Date: October 21, 2004

Subject: Request for additional information regarding Class II Permissive Change for
FCC ID: IHDT6EL1 (Portable PCS GSM Transceiver)

Application Received:	10/13/2004
Correspondence Reference Number:	241020A.IHD
Confirmation Number:	TC4347
Date of Original Email:	10/20/2004

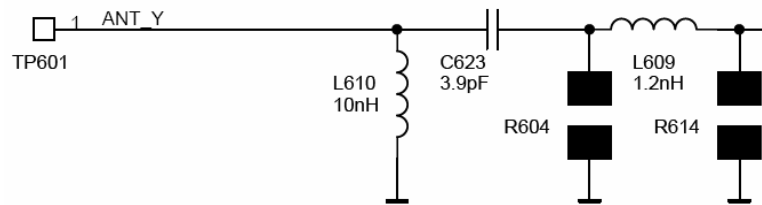
1. Please confirm that the following is a typo: p.5 of the SAR report- the SAR levels and tissue parameters listed for the 2 dates of validation tests appear to be reversed.

Response: Please refer to the supplement to the SAR report submitted on 10/21/04.
